December 16, 2022

Ochoco National Forest
3160 NE Third Street
Prineville, OR 97754

COTA is pleased and impressed by the thoroughness of the draft Environmental Assessment (EA) produced by the US Forest Service for the Lemon Gulch Trails Project. While the process has been long and some concerns have been raised, the EA clearly shows that the Lemon Gulch trail network is uniquely suited to help achieve the current and future needs of recreationists in the Ochoco National Forest and can be implemented in a manner that balances the needs of natural resources and multiple uses of the land.

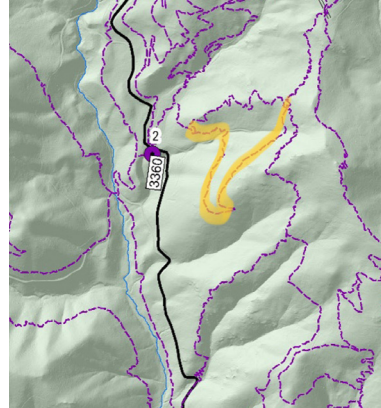
The first issue with trail design in Alternative 6 is the removal/realignment of the North-South arterial trail below FSR 3360. The original trail layout designed this to be an easy green trail that all riders, regardless of ability or type of bike, could use to reach the bottom of the network. In Alternative 6, this has been moved to a position above FSR 3360. The terrain here is extremely steep, exposed and rocky and would risk rock and debris falling into road traffic. Additionally, it appears this would require riders to ride uphill to access this trail before descending to the lower trailhead. Riders on downhill bikes, or on aMTBs may not be able to do this. The result of this is that the middle trailhead could likely become the primary location for shuttling, as riders would simply avoid continuing down to the bottom of Lemon Gulch. The limited space available here makes this less than ideal. Removing this catch trail also removes the most accessible green/easy trail in the network and encourages more bicycle traffic down FSR 3360.

The second notable point on Alternative 6 is the omission of the short trail near the middle area of the network (yellow line on attached image). It is included on Alternatives 2, 3, and 4 and it does not appear that the EA identifies any specific environmental or resource concerns with this trail. It falls on an open ridge line that does not appear to have specific grazing concerns and is surrounded by other trails, therefore, would not fracture the existing wildlife corridors. While short in distance, we would recommend including this as part of Alternative 6. It is mapped as one of the easier trails and would provide another option for beginner or intermediate riders. Adding this trail to Alternative 6 is especially important if the green/beginner North-South arterial trail is not also added to Alternative 6.
